S E R V I C E N O T E

**8566B Spectrum Analyzer
85660B RF Section**

Recommended replacement for A10A6U2 OP AMP**Situation:**

DATE: October 1994

Figure 1. How to form the part (bottom view).

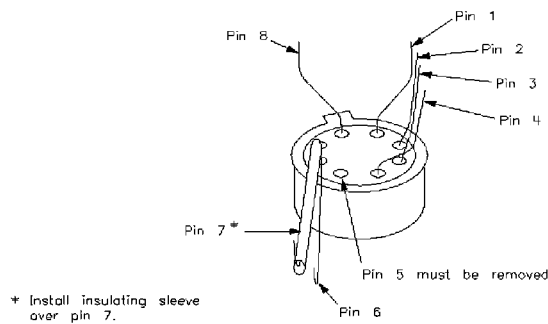
Figure 1 shows the bottom view of the op amp. The op amp leads are pointing towards you. Remove (cut off) lead 5 and form the remaining leads as shown.

Insert insulating tubing over lead 7 to prevent lead 7 from shorting to lead 6.

Figure 2. Top view of U2 loaded into the PC board.

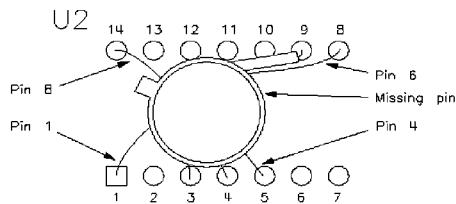
Figure 2 shows U2 inserted into the PC board.
